MILLSTONE NUCLEAR POWER STATION, UNIT NO. 2

AMENDMENT TO FACILITY OPERATING LICENSE

Amendment No. 55  
License No. DPR-65

SAFETY EVALUATION BY THE OFFICE OF NUCLEAR REACTOR REGULATION

Figure 3.2-1 Allowable Peak Linear Heat Rate vs Burnup

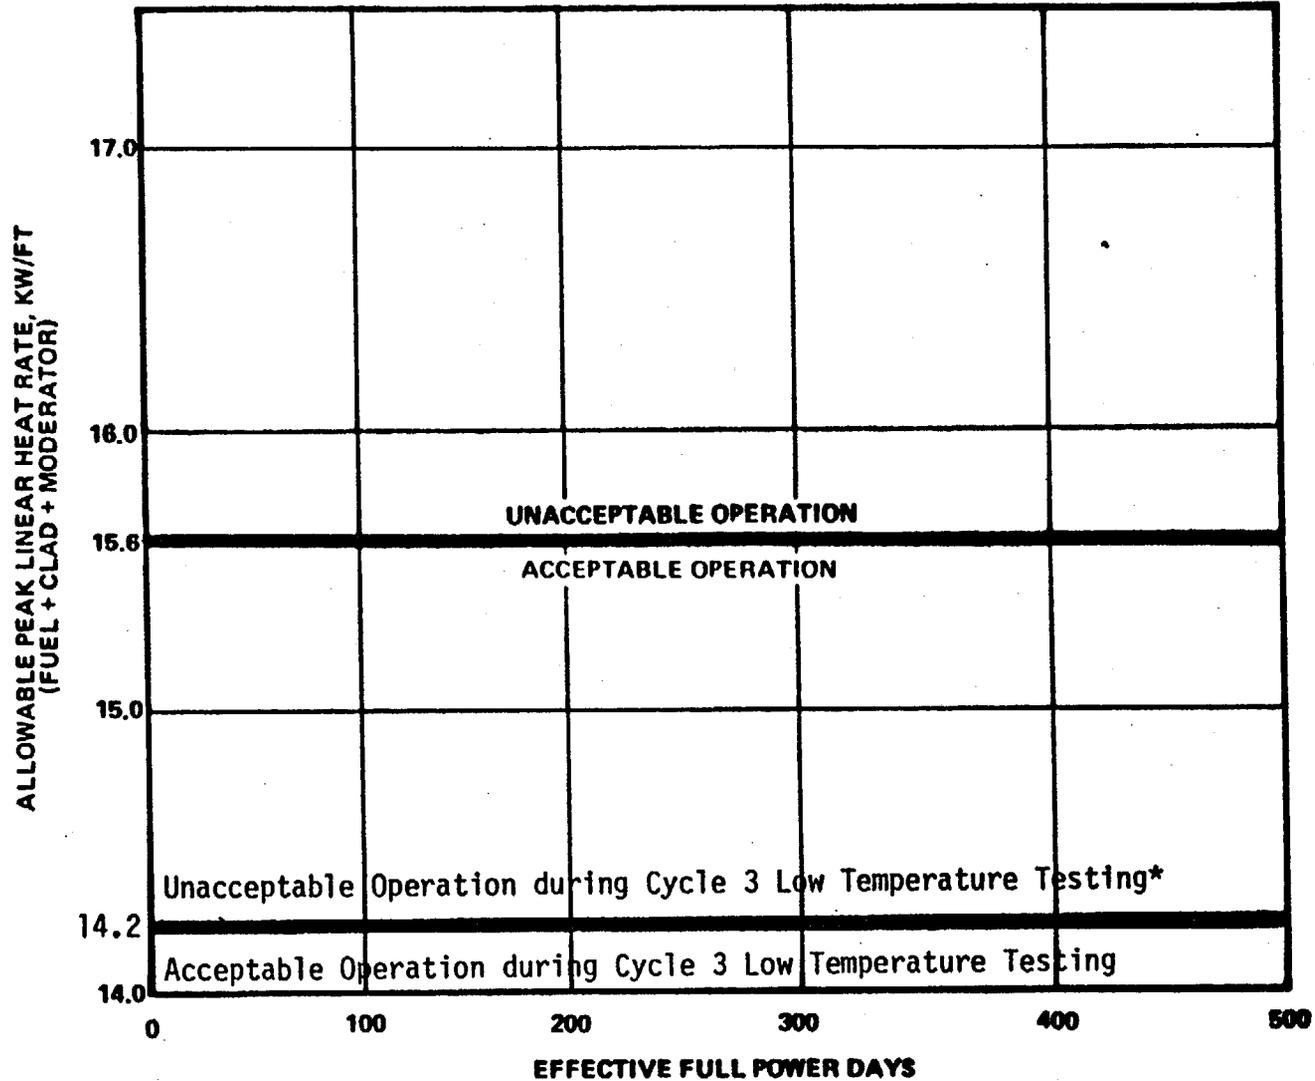
Our review indicated that changes to Technical Specification page 3/4 2-3 needed to be made in order to authorize the proposed testing. These changes have been discussed with and agreed to by your staff.

We have concluded, based on the considerations discussed above, that this test may be performed safely and with no adverse consequences and does not involve a significant decrease in safety margin provided Technical Specification Figure 3.2.1 is modified to impose the above limits during the testing.

\*During Cycle 3, low temperature testing is authorized for periods not exceeding 24 hours with the inlet temperature greater than or equal to 537°F and without varying the programmed pressurizer level.

- Test duration not to exceed 24 hours
- Minimum inlet temperature  $\geq 537^{\circ}\text{F}$
- Maximum LHR  $\leq 14.2$  Kw/ft
- Pressurizer level will not be varied with the reduced average temperature
